Access Compliance Report

Public Rights-of-Way

(Curb Ramps)

Intersection ID: 10017210	Main Street: HIGHLAND_AV	Cross Street: N/A	Location: SE
ADA ID: 26AC49E2A7FF	Ramp Type: PerpDiag	Initial Pass/Fail: Fail	Overall Compliance: No
		Severity Score: 25

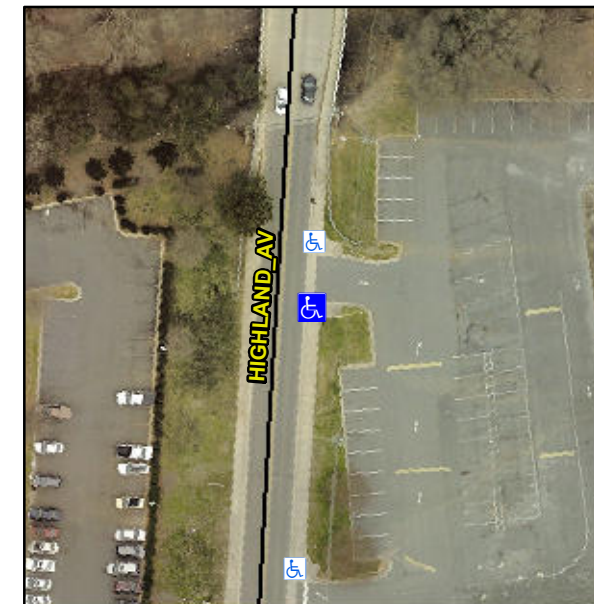
R304.5.3

Compliance	Description	Data	Compliance	Description	Data
N/A	Ramp Length (in)	72.0	Yes	Ramp Slope (%)	5.9
Yes	Ramp Width (in)	57.0	No	Ramp XSlope (%)	7.2
N/A	Flare Type LT	N/A	N/A	Flare Type RT	N/A
N/A	Flare Slope LT (%)	N/A	N/A	Flare Slope RT (%)	N/A
N/A	Flare Traversable LT?	N/A	N/A	Flare Traversable RT?	N/A
N/A	Landing Length (in)	N/A	N/A	DWS Provided?	N/A
N/A	Landing Width (in)	N/A	N/A	DWS Contrast?	N/A
N/A	Landing Slope (%)	N/A	N/A	DWS Length (in)	N/A
N/A	Landing X Slope (%)	N/A	N/A	DWS Full Width?	N/A
N/A	Landing Curb? (Y/N)	N/A	N/A	DWS Offset (in)	N/A
N/A	Shared Landing?	N/A			
N/A	Gutter Ponding?	N/A	N/A	Gutter Slope (%)	N/A
N/A	Gutter Lip Ht (in)	N/A	N/A	Gutter X Slope (%)	N/A
N/A	Painted X Walk1?	No	N/A	Painted X Walk2?	No
	X Walk 1 Direction	To N		X Walk 2 Direction	To W
N/A	X Walk 1 Width (in)	N/A	N/A	X Walk 2 Width (in)	N/A
	X Walk 1 Slope (%)	2.4		X Walk 2 Slope (%)	3.0
	X Walk 1 X Slope (%)	8.8		X Walk 2 X Slope (%)	2.1

Remove & Replace Curb Ramp With Two New Directional Ramps or Equivalent.
